GOVERNMENT OF INDIA
MINISTRY OF ENVIRONMENT & FORESTS
Central Zoo Authority

F. No. 19-39/92-CZA(298)(Vol. V)(M)/5143

Sub: Proposed designs for the construction of various enclosures at Lucknow Zoological Garden, Lucknow.

LEOPARD ENCLOSURE LAYOUT PLAN

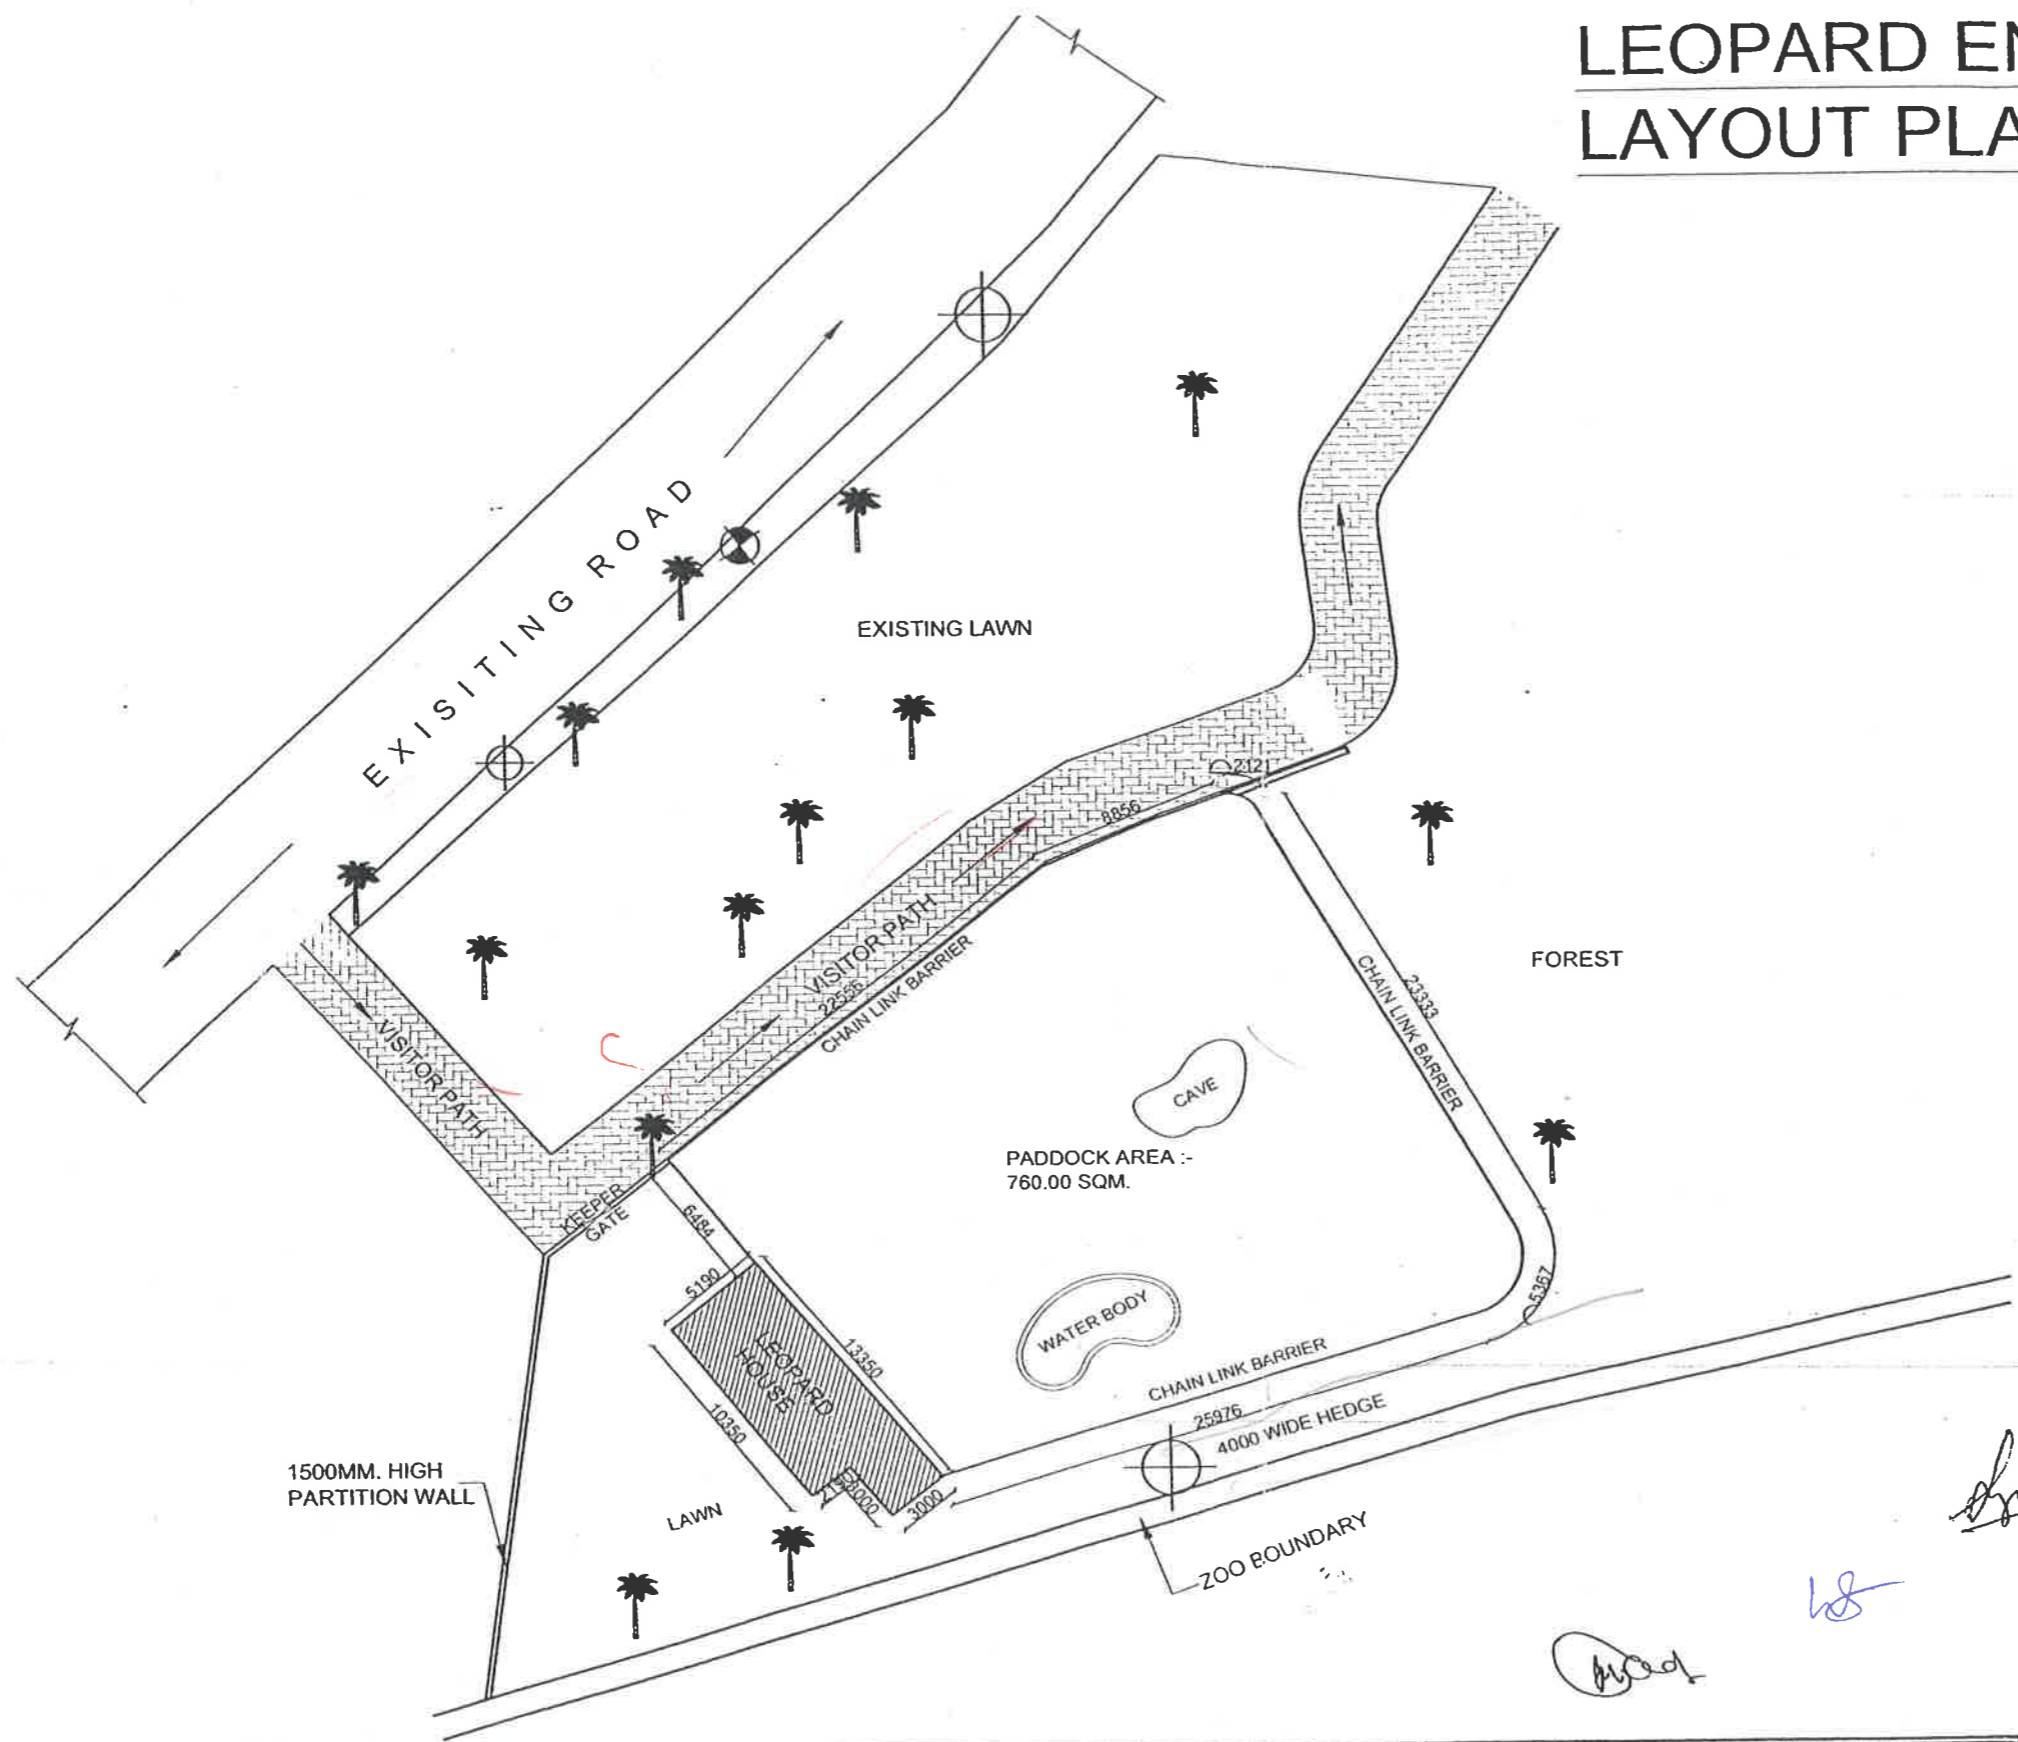
The design was scrutinized and approved subject to the condition that the height of the chain-link fencing should be increased to 5mts. from 4 mts.
